Aerial Photo of Existing Conditions for Context

The Public, Staff, Stakeholders and Council Speak-The Revised Design

Pier Washrooms Potential Upgrades

Current Washrooms & Deficiencies

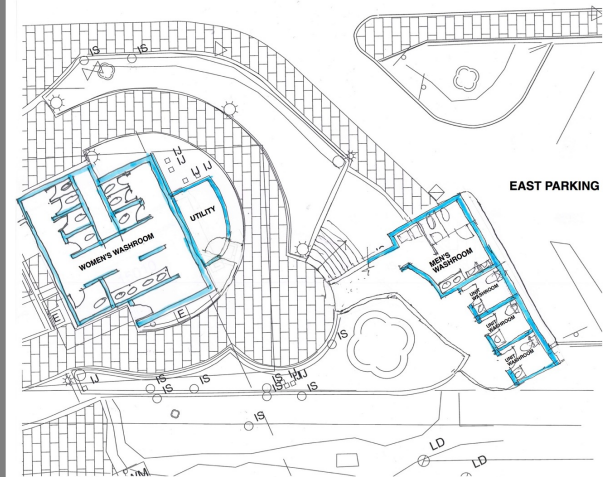
- Grossly inadequate facilities. Especially women's washrooms.
- Lacking proper Unit Disabled Washroom
- Dated facilities and in need of refreshing
- Internal layout and accessibilities not in conformance with current standards and code

- **Number of Female toilets:** since no specific codes to refer to, the current consensus is to increase the number of female toilets from the current 3 up to a total of 8. This would equate to a building code capacity of up to 200 females, in relation to assembly occupancies.

- **Numbers of male toilets/urinals:** currently there are 4 toilet/urinals. At this time there does not seem to be a lack of these. In fact the current number of toilet/urinals for a capacity of 200 males in an assembly occupancy in relation to the building code is 4. So the current allotment of 4 toilet/urinals will be maintained, with the possible addition of one urinal.

- **Unit washrooms for Disabled and All:** none currently exist, so it is proposed to provide 3 identical unit washrooms, suitably laid out.
- **Design Standards:** it is proposed that in designing the washroom additions and renovations the updates will bring the facilities to modern standards and concentrate on adequate accessibility along with high quality specifications for maintenance.

OPTION 2

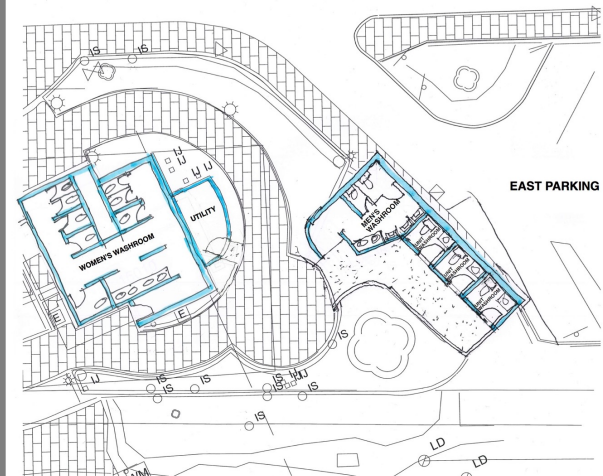
Option 2 expanding the current washroom footprint was the hands-down winner.

More benches for seniors wherever you fit them 2. Bathroom option two preferred. If #1 is chosen, the 3 utility bathrooms should be attached to womens bathrooms not mens b/c women have the kids most of the time
